DEPARTMENT OF NATURAL RESOURCES
DIVISION OF OIL, GAS AND MINING

Re: TDN #89-02-116-002, Blazon Mine No. 1, North American Equities, ACT/007/021,
Carbon County, Utah

FIGURE 7

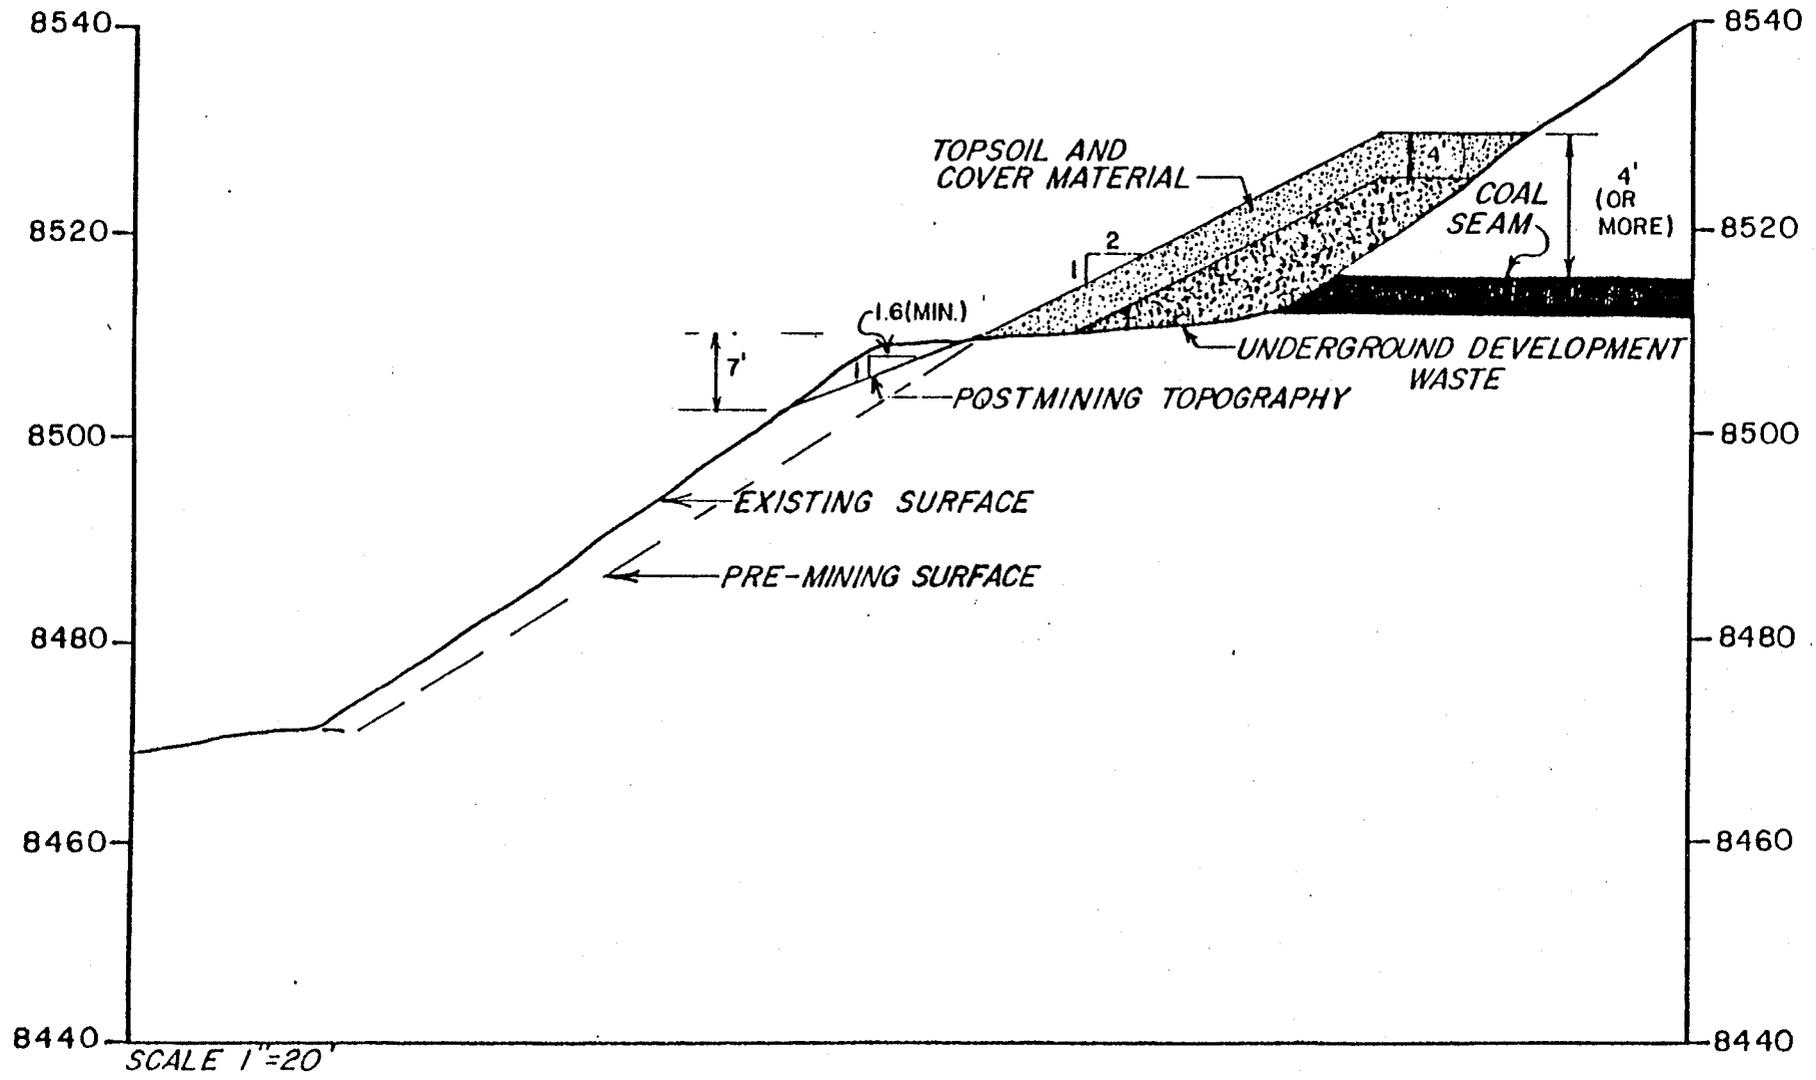
I have also attached a copy of Figure 7, from the approved mining and reclamation plan, Typical Section of Reclaimed Mine Bench, which supports the final configuration of a cut and fill terrace on the portal bench.

The as-built configuration of the reclaimed portal bench is generally that depicted in the above-referenced Figure 7. In the approximate center of the reclaimed portal bench, the present configuration of fill placement blends into the undisturbed slope with the elimination of the cut and fill terrace for roughly 40 feet. Examination of photographs taken during the past two field seasons (including those sent you earlier this year) suggests that where the cut and fill terrace was not implemented, runoff has been concentrated across the fill, with the resultant need to place the log erosion control devices shown in the photographs.

Clearly, the cut and fill terrace is functioning as contemplated in the regulations with the minor exception noted above. The placement of the log erosion control devices has, as noted, allowed the reclaimed configuration to meet performance standards.
